*FINAL*  
**ENVIRONMENTAL ASSESSMENT**  
**FOR A**  
**COMBINED POWER AND BIOMASS HEATING SYSTEM**  
**FORT YUKON, ALASKA**

**APPENDIX B**  
**AGENCY CORRESPONDENCE**

SUBJECT: SECTION 106 CONSULTATION FOR THE FORT YUKON COMBINED  
BIOMASS HEATING SYSTEM PROJECT (FILE NO. 3130-2R AEA)

Figure 2 - Project Location, Harvest and Storage Areas

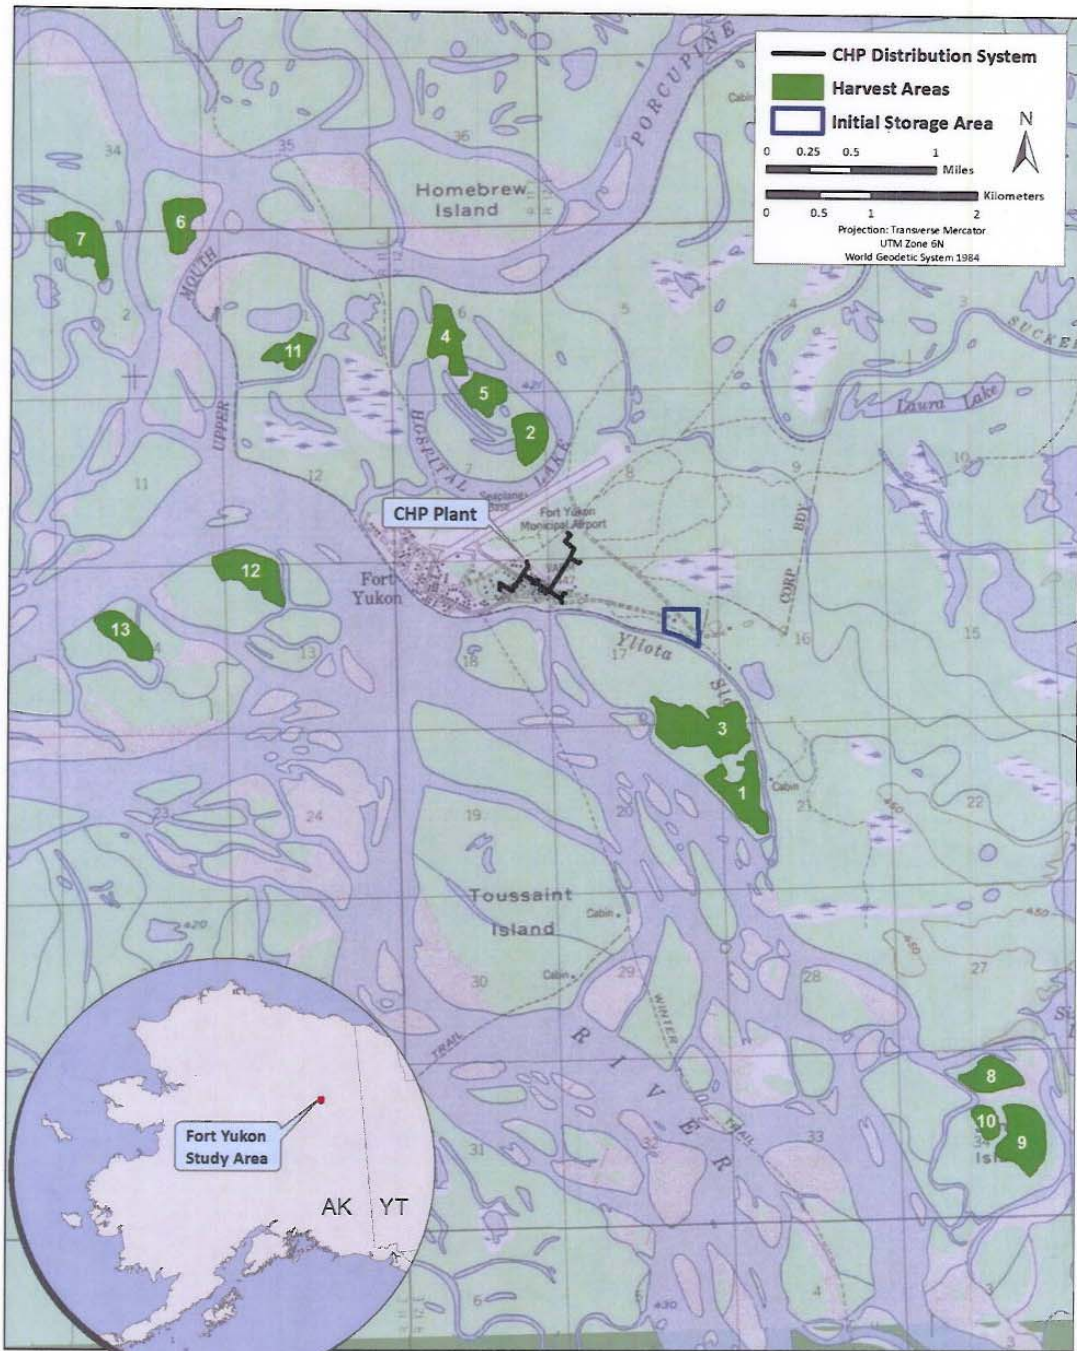
There are a number of known cultural resources in the vicinity of Fort Yukon and according to your letter, areas of cultural and historical significance in the vicinity of the proposed activities were identified by the Council of Athabascan Tribal Governments Natural Resources Department and the Gwichyaa Zhee Gwich'in Tribal Government Lands Committee. However, no additional details were provided in your documentation regarding these areas. Additionally, your documentation suggests that each proposed harvest area will be examined prior to harvest to identify any unmapped sites. We recommend that if this investigation is already planned, it should be conducted by a qualified archaeologist or cultural resource specialist and that the results of the investigation be provided to our office prior to initiating work. Should any cultural resources be identified during this investigation, they should be evaluated for eligibility to the National Register of Historic Places in accordance with standard practice. Finally, the maps provided show both "wood storage areas" and "initial storage area," but no additional information

is provided to describe the proposed activities in these areas or their potential for effects. Our records indicate that the "initial storage area" polygon is located in an area of several previously-recorded cultural resources.

Harvest areas in Fig. 2 appear to be 40-100 acres in size, well within the size of typical wildland fires on upland sites in this physiographic section of interior Alaska (average about 2,000 ac). Larger cut areas with islands of uncut mature trees may be easier to lay out and help retain cavity trees or other desired late-seral features against windthrow after harvest. Larger cuts will also likely increase tree survival by reducing the potential for hare and moose herbivory away from edge cover (increased predation risk). Where feasible, hardwood harvest should be timed during the low phase of the hare abundance cycle to aid regeneration success.

In the vicinity of the initial storage area is FYU46 White Alice Communication System (WAC) which includes sites FYU57-80. Figure 2 shows an overview of the vicinity, with the initial storage area in the left central portion of the figure. The project proposes to use a building, known locally as "the Quonset hut" to store biomass and biomass harvest equipment in the initial storage area. This building is located within the parcel designated for the initial storage area and is designated site FYU66, built in 1956, and currently used for community recyclables. Figure 3 shows the initial storage area parcel within which FYU66 is located. This site is associated with the Fort Yukon Long Range Radar System (LRRS) and was determined eligible for the National Register of Historic Places (NRHP) as part of the Aircraft Control and Warning (AC&W) System and in an MOA signed by the Air Force, SHPO and ACHP, and approved January 1998 in conjunction with the Clean Sweep program. The preservation strategy was to document the facilities before demolition. FYU66 was documented in accordance with the MOA requirements, along with many other sites, some now demolished. Subsequently, as part of the decommissioning of the LRRS, the building and the initial storage area were deeded to the Gwitchyaa Zhee Corporation in 2005.

The area designated as the initial storage area has been previously disturbed. Buildings and installations have been removed and contaminated sites have been cleaned up. In order not to disturb the ground further, vegetation would be cleared by cutting at the surface level, thus leaving the root and soil structures undisturbed. Biomass would be placed on the ground surface for storage.
